City of Westminster
Addendum #1
Project: RFB #21-05/Contract #R-287-C
September 21, 2020

Pre-Bid Meeting for Storm Drain Pipes Upgrade

Questions Submitted by Bidders:

Location: Business Pkwy South

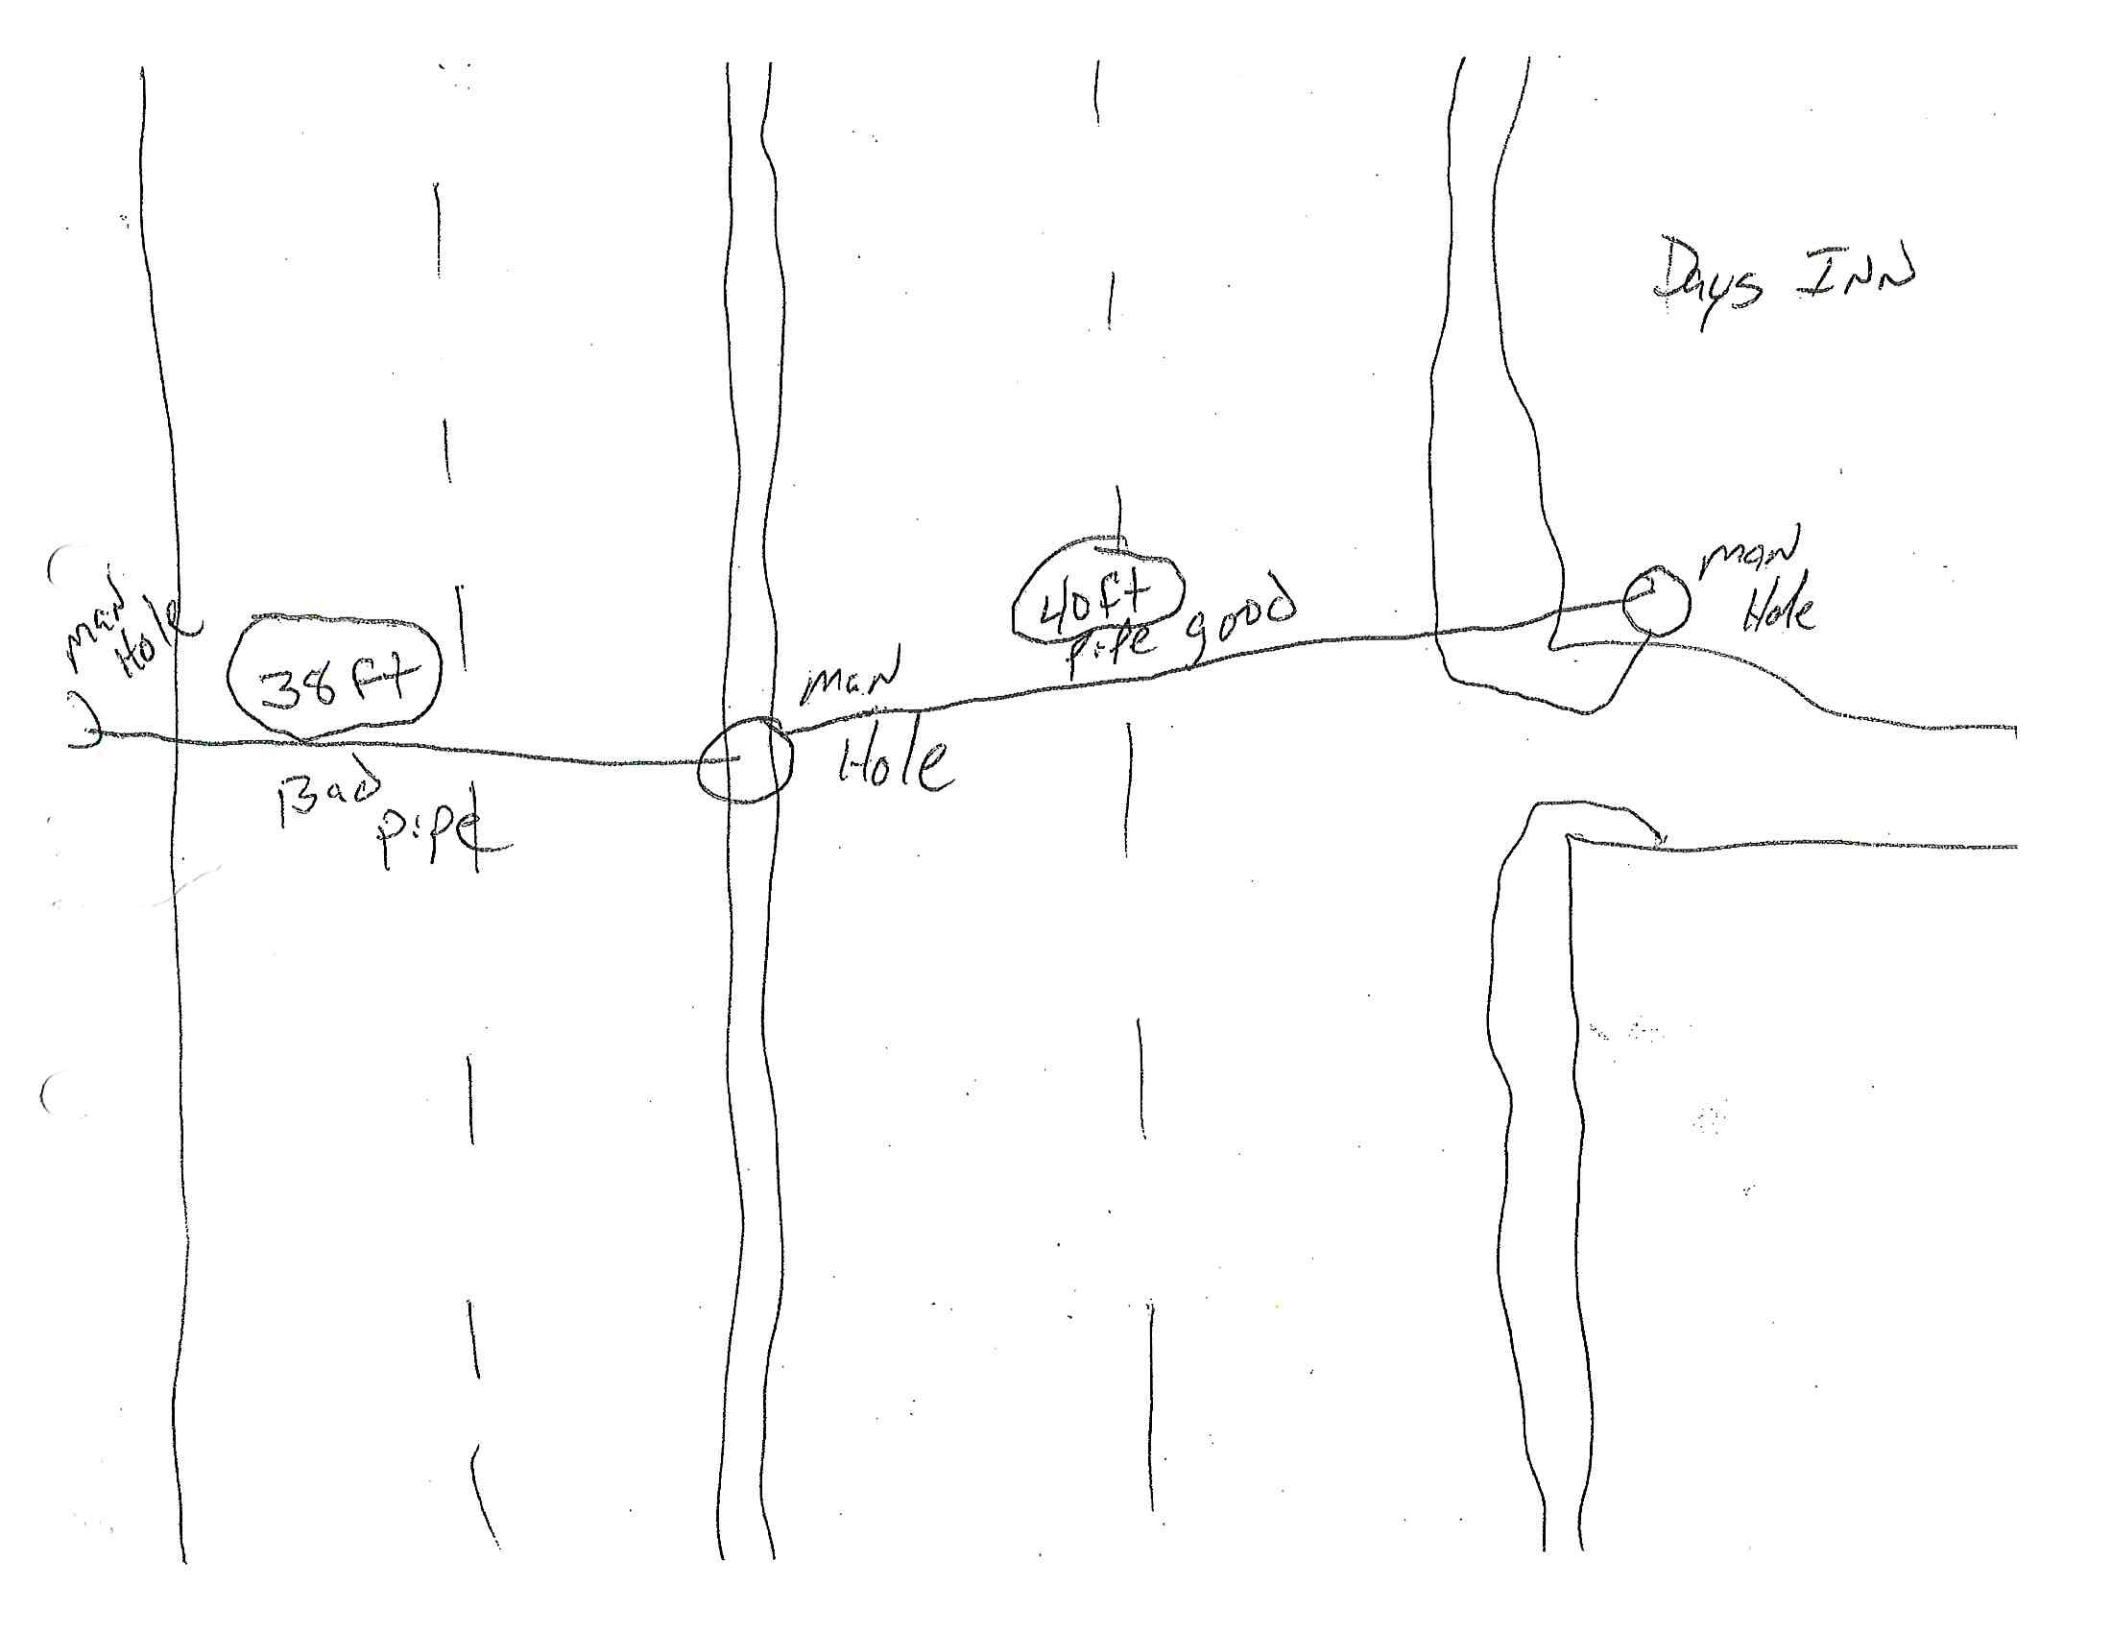
4. **Question:** Are there any drawings or location maps?
   Answer: Yes, as-built drawings and maps are attached. Reliance on as-built drawings are at the risk of the potential bidder, as the City was not involved with the original installation.

Days INN
man Hole
36 ft
Bad pipe
man Hole
40ft pipe good
man Hole
